**DESCRIPTION:** Site Plan of a Commercial Development

**CASE NUMBER:** SP-03-15

**REPORT PREPARED BY:** Boyd V. Stanley, AICP Development Review  
Administrator and Kevin Ashley, AICP Planning and  
Development Manager

**Christenbury Corners  
Northwest Quadrant**

C2 WEST ELEVATION  
PR-01 3/32" = 1'-0"

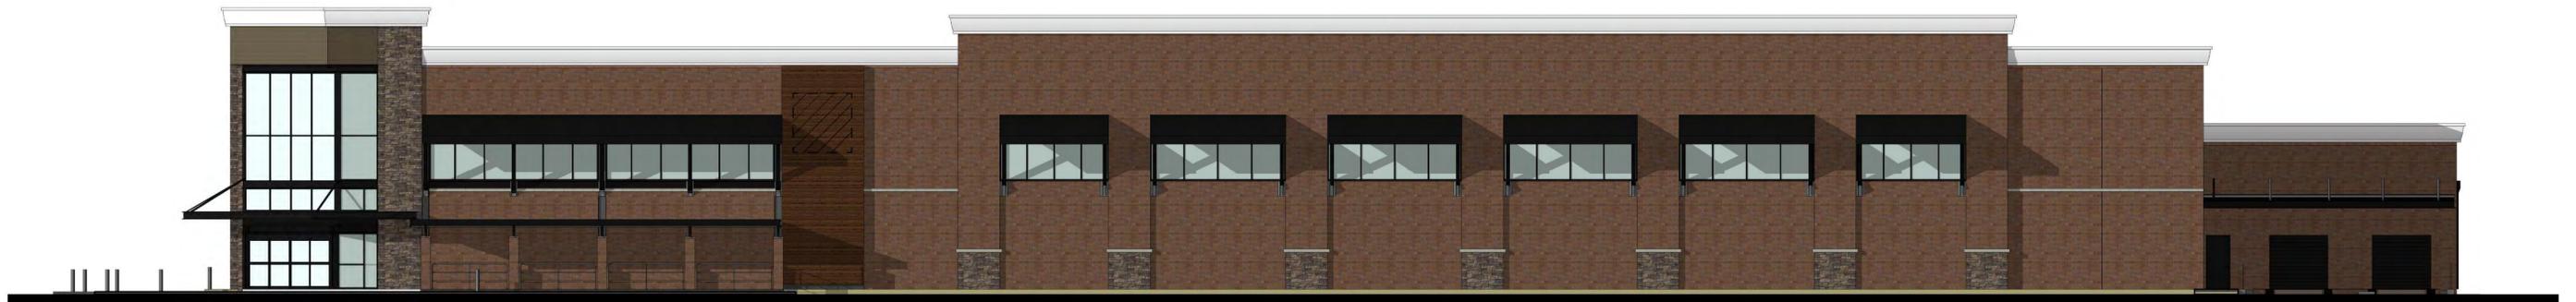
The proposed grocery store (labeled as “Grocery Store Elevation”) is similarly clad with the combination of brick and stone. The staff has advised the applicant that the west grocery store elevation will need some treatment to address the expanse of bland wall. The staff has worked with the grocery store developer to move the design more toward one that is consistent with the approved technical data sheet as well as the approved development on the southwest quadrant.
